**Rutland County Council**

Application:	<b>2022/0646/FUL</b>	<b>ITEM 1</b>	
Proposal:	<b>Demolition of existing agricultural barn and erect 2 no. 3 storey dwellings, relocation of entrance doors to barn No 2 to the rear, extension of existing farm track, creation of new parking and turning area to the rear of barn 2.</b>		
Address:	<b>Fairchild Lodge, Lyddington Road, Caldecott, Rutland</b>		
Applicant:	<b>Mrs Louise Brown</b>	Parish	<b>Caldecott</b>
Agent:	<b>Mr Tony Ansell</b>	Ward	<b>Lyddington</b>
Reason for presenting to Committee:	<b>Member application</b>		
Date of Committee:	<b>14 February 2023</b>		
Determination Date:	<b>21 July 2022</b>		
Agreed Extension of Time Date:	<b>17 February 2023</b>

AB/02B/PL/2022

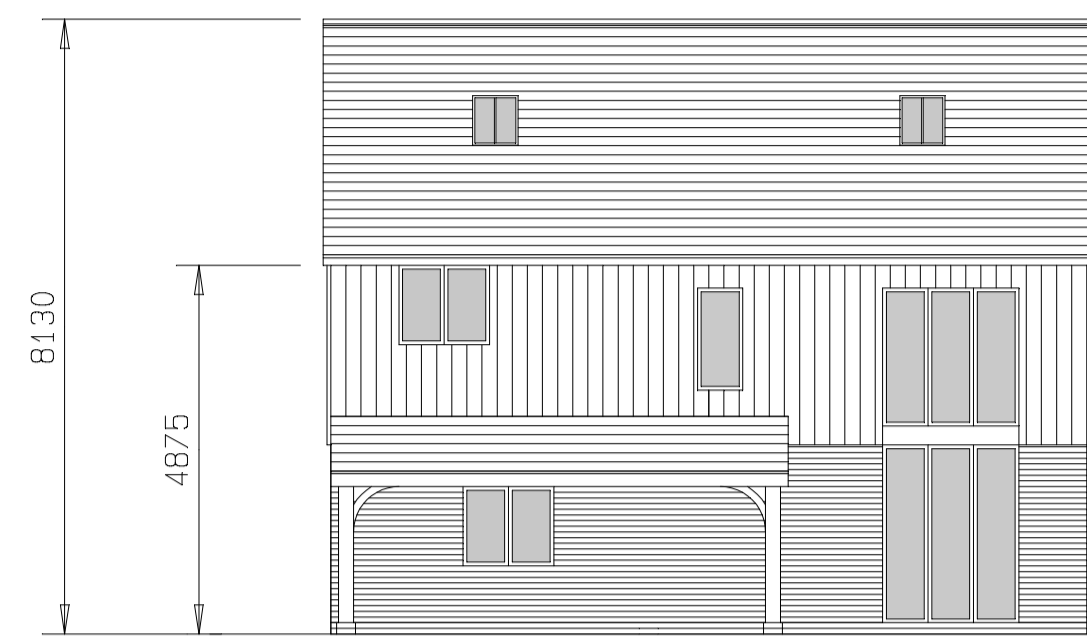
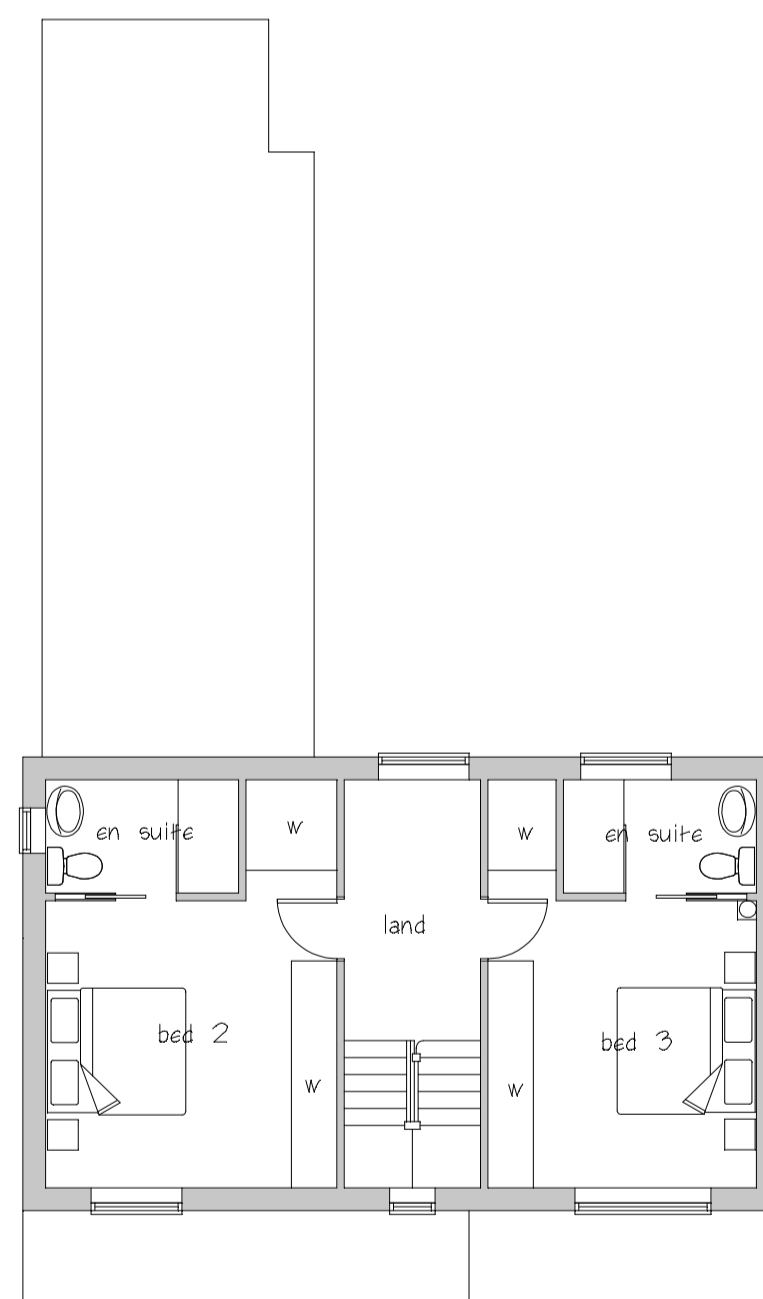
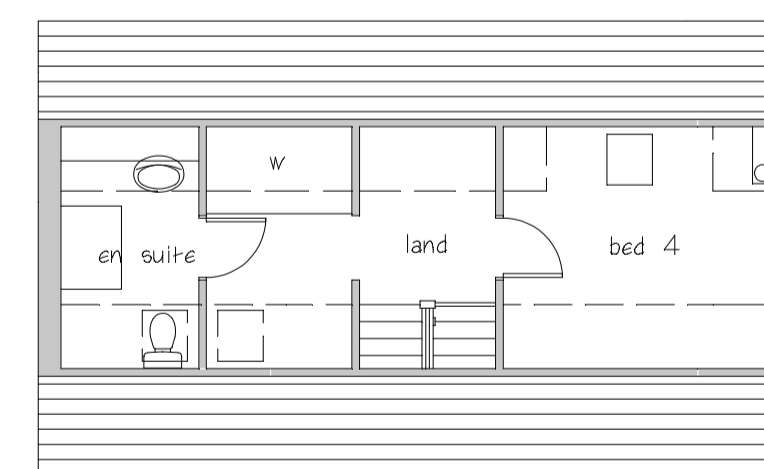
Dwelling A - central glazed element now all one as discussed - Dwelling B - solid element under porch removed allowing porch to overhang - although there is now a smaller solid element labelled 'store' - more info on this needed - assuming brick? If having, needs recessing behind timber posts but may still look odd

Further to the revisions made to the above application in December 2022, I can confirm that the open porch on Dwelling B is now acceptable. The previous amendments made in November 2022 have been covered in my comments of 11 November 2022 and since the scheme was submitted in May 2022 – the original (built and landscape) proposals have been improved significantly to sit more comfortably in to the site and context.

Rev A Aug 22: Dormers replaced with roof windows  
 Rev B: Fenestration altered. Vertical boarding & render introduced to front elevation. Flue added
